AGENDA
PLANNING AND ZONING COMMISSION MEETING
CITY OF CREVE COEUR, MISSOURI
MONDAY, JUNE 1, 2020

1. PUBLIC HEARING. Application #20-002 & #20-010: Boundary Adjustment, Site Development Plan and Conditional Use Permit for QuikTrip Gas Station with Convenience Store at 11004, 11026, and 11032 Olive Boulevard and 825 and 827 Graeser Road, and the Redevelopment of the Adjacent Retail Center at 11032 and 11056 Olive Boulevard

**APPLICATION TO PLANNING AND ZONING COMMISSION
#20-002 & #20-010: BOUNDARY ADJUSTMENT, SITE DEVELOPMENT
PLAN AND CONDITIONAL USE PERMIT FOR QUIKTRIP GAS STATION
WITH CONVENIENCE STORE AT 11004, 11026, AND 11032 OLIVE
BOULEVARD AND 825 AND 827 GRAESER ROAD, AND THE
REDEVELOPMENT OF THE ADJACENT RETAIL CENTER
AT 11032 AND 11056 OLIVE BOULEVARD**

REPORT PREPARED BY: Whitney Kelly, AICP, City Planner
DATE: 5/26/2020
ATTACHMENTS: Applicant's Revised Materials received May 11, 2020
MoDOT Comments
City's Traffic Engineers, GBA, Response Letter
CBB response to comments dated May 26, 2020 and May 28, 2020
Letter from Graeser Neighbors received May 20, 2020
Comments received by May 28, 2020

Figure 24: Close-up of the rendering of the monument sign

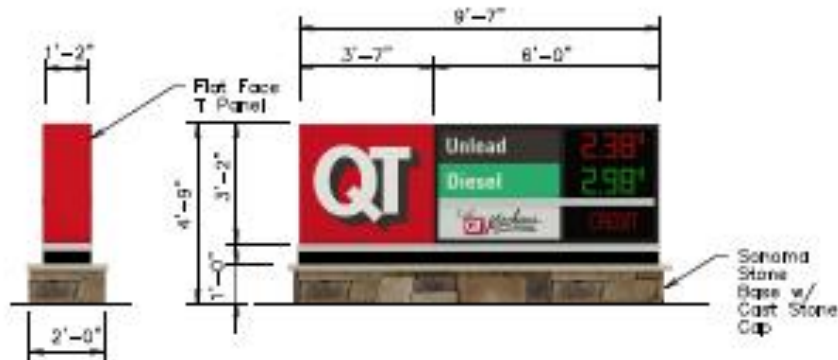
Further, Section 405.950(I) Gasoline Price Signs, provides for one (1) gasoline price sign allowed on the property. This sign must be freestanding and permanently anchored with a masonry base at least one (1) foot in height. Such a sign shall not exceed thirty (30) square feet in sign area per face and shall not exceed six (6) feet in height from top of sign to top of grade. Section 405.930(D)(13) provides that these signs are only to be manually changeable signs, where electronic changeable signs are prohibited. The renderings appear that the price is electronically changeable.

Figure 25: Close-up of the Boundary Adjustment Plat

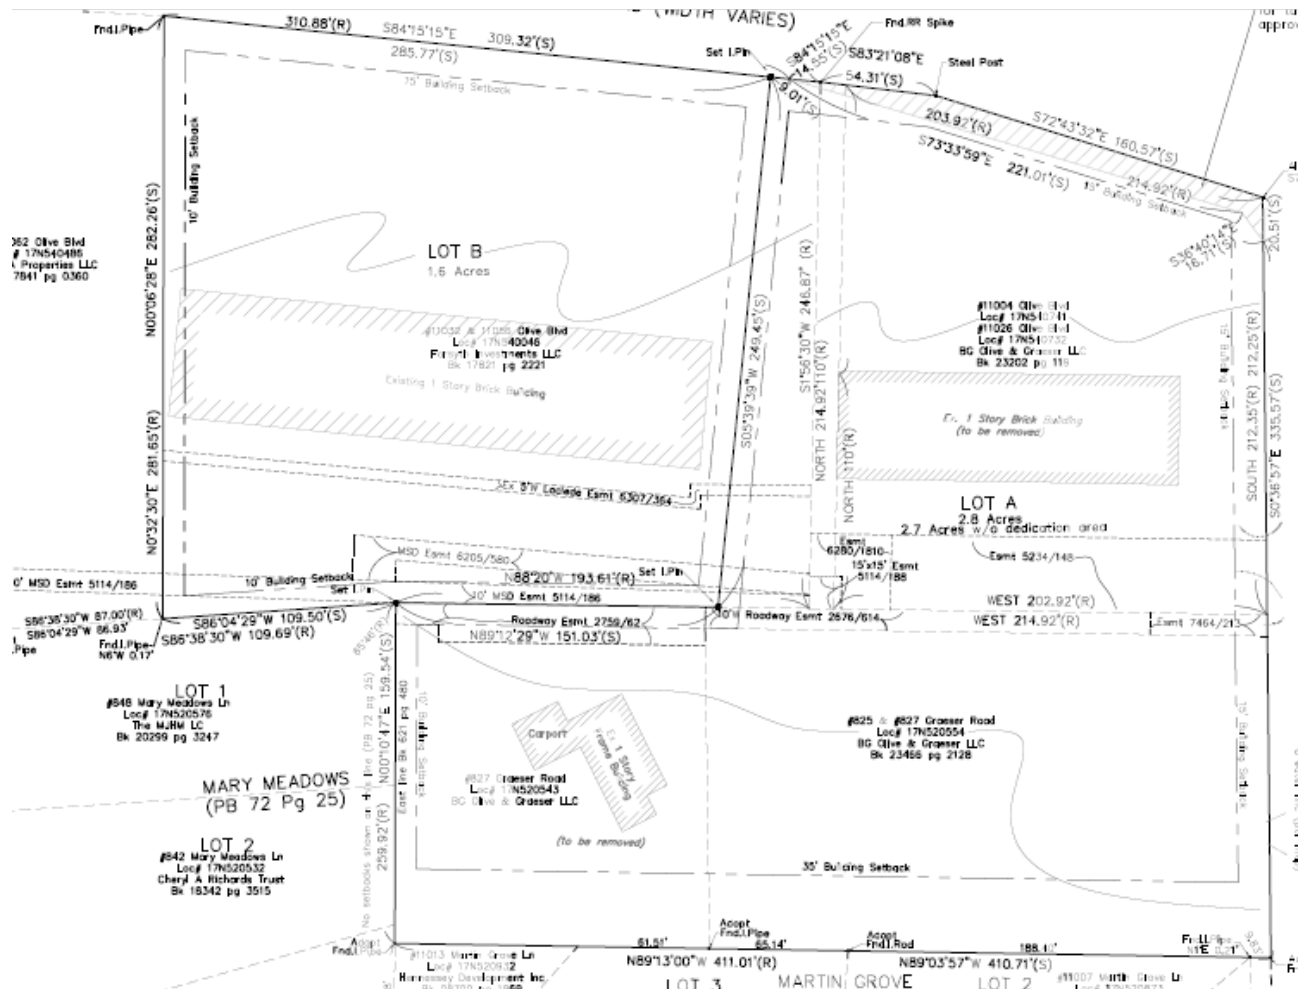
As part of this request with Application #20-010, the Applicant has submitted a plat that would consolidate the existing six (6) non-conforming lots into two (2) lots. One lot would be for the Gas Station and Convenience Store and for the stormwater detention areas that serve both properties and the landscaped buffer yard area, and one lot would be for the retail center. The site development plan indicates 2.54 acres for the QT lot (+0.06 acres dedicated for right-of-way), and the second lot is shown at 1.82 acres with (+0.01 acres dedicated for right-of-way, while the Boundary Adjustment Plat and legal descriptions show 2.8 and 1.6 acres for the lots. Therefore, coordination between the Boundary

Adjustment Plat, the Site Development Plans and landscape plan is needed with the correct information, including site data tables.
